**Re: Big Wave Project FEIR**

On behalf of the Pillar Ridge Homeowners Association, I submit the following comments on the Big Wave Project Final EIR and the staff report for the 10/27/10 public hearing. Due to the extremely short public comment period for such lengthy complex documents, our comments are necessarily rushed and incomplete. Please extend the public comment period to a minimum of 60 days to allow a more complete review. Please require complete story poles with the standard visible orange mesh during the entire review period.

(FIGURE 10)

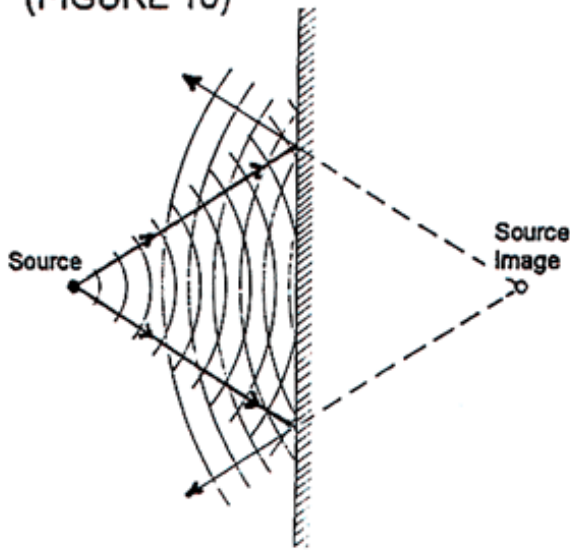
The EIR does not address impacts of single-event aircraft take-off noise reflecting off tall office buildings toward the residences at Pillar Ridge. Without studies or references, the EIR response makes the assumption that this effect would only be directed at the propane service yard at one corner of our community. (comment 185-36)

Since airplane take-off noise is not a single location but travels along the runway, and the Pillar Ridge homes lie over a 22-acre area, the increased airport noise from reflection would cover a large area and be a significant impact for us. To say that some future trees may grow 50 feet tall, or that our 6-foot perimeter chain link fence will buffer any noise reflected off 46-foot-tall buildings to our single-story homes is grossly inadequate. Trees generally do not attenuate sound.
